London Luton Airport Expansion

**8.49 Applicant's Post Hearing Submission - Issue Specific
Hearing 3 (ISH3)**

Application Document Ref: TR020001/APP/8.49

Figure 1: Wizz Air orders (Source: Wizz Air Analyst Presentation 25/26 September 2023)

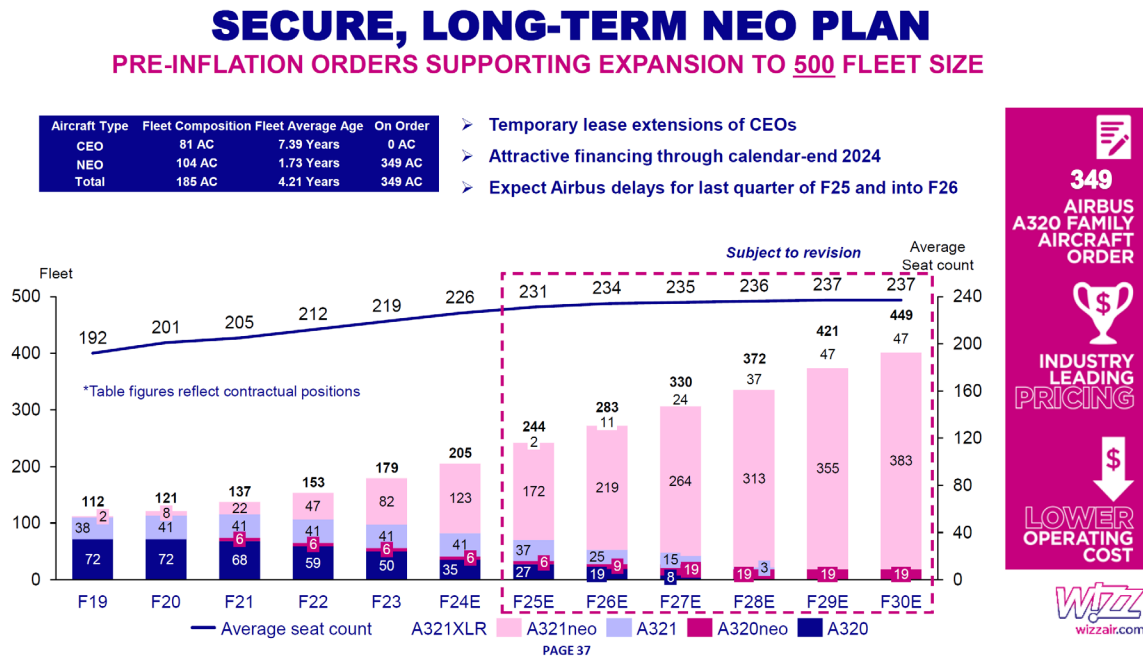
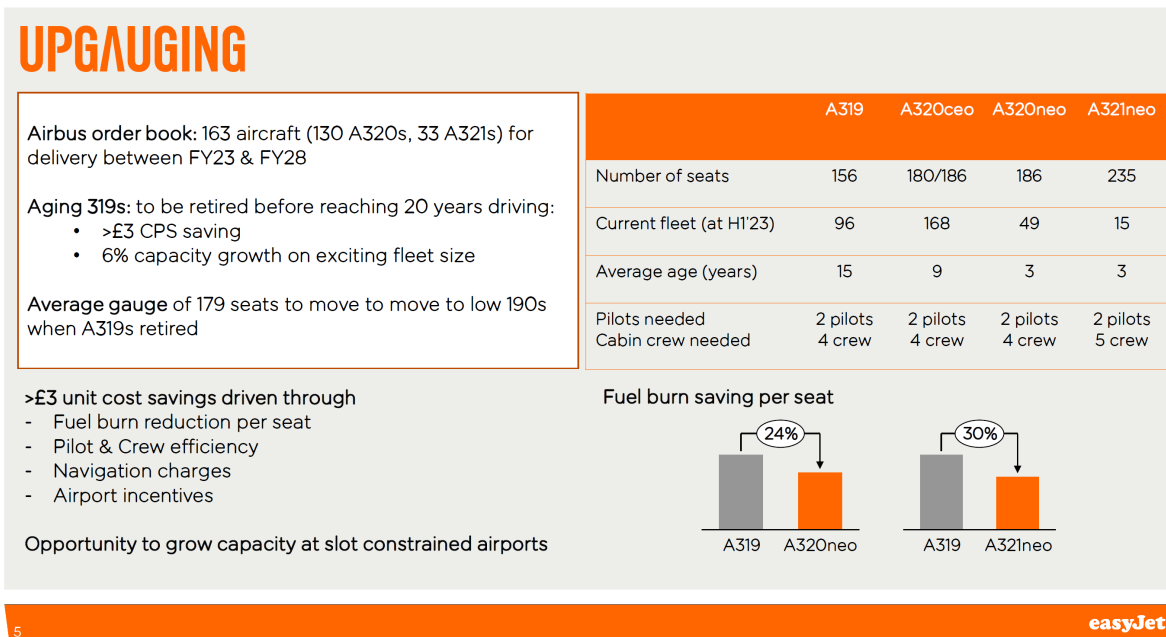
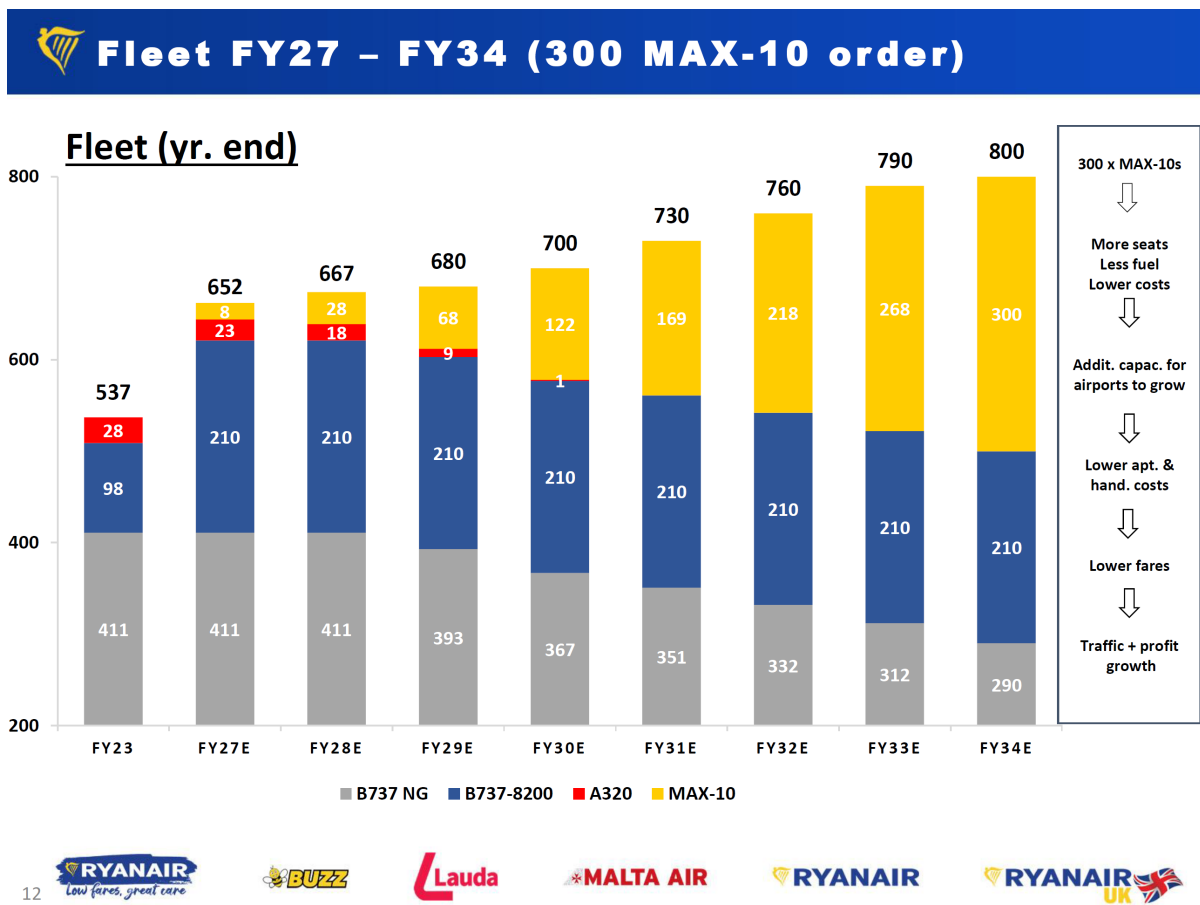
- 6.3.3 **Action 21: Provide information regarding airline orders and annual reports to demonstrate certainty in relation to the assumptions on fleet replacement/ modernisation.**

- 6.3.4 ***Post Hearing Note:*** Figure 1 to Figure 3 provide information from Wizz Air, easyJet and Ryanair on their airline orders. Note that the easyJet orders relate to Airbus Neo aircraft. easyJet is also seeking additional orders, subject to delivery slots from Airbus, to replace older generation A320ceo aircraft before they reach the age of 20 years.
